2025MY
Carnival HEV (KA4 HEV)

TECHNICAL SERVICE BULLETIN

SUBJECT: **SERVICE ACTION: MCU DTC LOGIC IMPROVEMENT (SA617)**

UPGRADE EVENT:

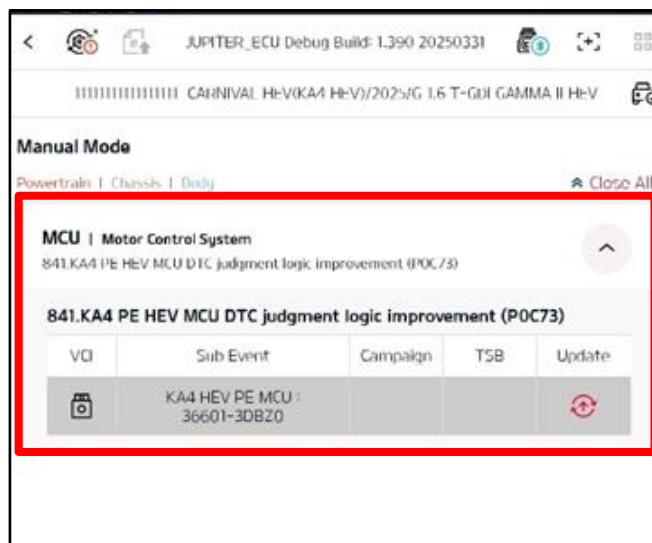
Select the applicable **'MCU'** system module and the Event Group.

- 841.KA4 PE HEV MCU DTC Judgment Logic Improvement (P0C73)

Verify the affected vehicle Calibration Identification of the applicable ECU ROM ID and reference the Information Table on page 3 as necessary.
